Access Compliance Report

Public Rights-of-Way

Intersection ID: 15160	Main Street: GRIFFITH_ST	Cross Street: S_TRYON_ST	Location: SE
ADA ID: DB47A7CF3602	Ramp Type: Perp	Initial Pass/Fail: Fail	Overall Compliance: No
Severity Score: 22.5			
Codes/Mitigation Info/Possible Solution		Field Measurements/Component Compliance

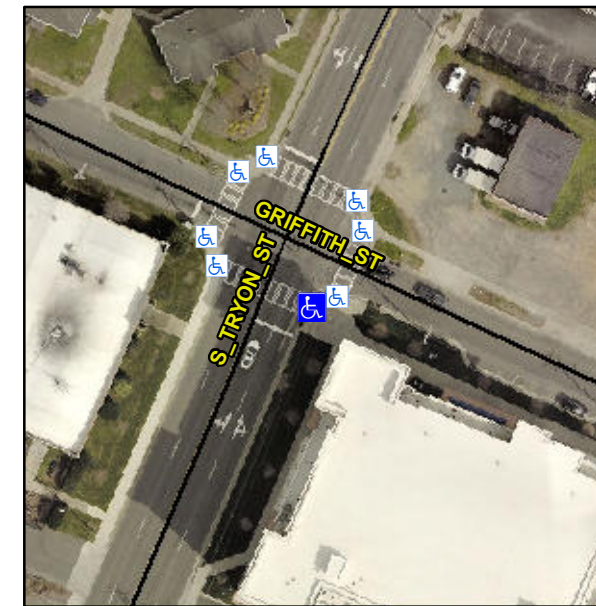
Not Found, R304.5.1, R304.2.2, R304.5.3

Compliance	Description	Data	Compliance	Description	Data
N/A	Ramp Length (in)	108.0	No	Ramp Slope (%)	8.6
No	Ramp Width (in)	46.0	No	Ramp XSlope (%)	3.8
N/A	Flare Type LT	N/A	N/A	Flare Type RT	N/A
N/A	Flare Slope LT (%)	N/A	N/A	Flare Slope RT (%)	N/A
N/A	Flare Traversable LT?	N/A	N/A	Flare Traversable RT?	N/A
N/A	Landing Length (in)	N/A	N/A	DWS Provided?	N/A
N/A	Landing Width (in)	N/A	N/A	DWS Contrast?	N/A
N/A	Landing Slope (%)	N/A	N/A	DWS Length (in)	N/A
N/A	Landing X Slope (%)	N/A	N/A	DWS Full Width?	N/A
N/A	Landing Curb? (Y/N)	N/A	N/A	DWS Offset (in)	N/A
N/A	Shared Landing?	N/A			
N/A	Gutter Ponding?	N/A	N/A	Gutter Slope (%)	N/A
N/A	Gutter Lip Ht (in)	N/A	N/A	Gutter X Slope (%)	N/A
N/A	Painted X Walk1?	Yes	N/A	Painted X Walk2?	N/A
	X Walk 1 Direction	To NW		X Walk 2 Direction	N/A
N/A	X Walk 1 Width (in)	117.0	N/A	X Walk 2 Width (in)	N/A
	X Walk 1 Slope (%)	1.2		X Walk 2 Slope (%)	N/A
	X Walk 1 X Slope (%)	2.3		X Walk 2 X Slope (%)	N/A

Possible Solutions:

Remove & Replace Entire Ramp.
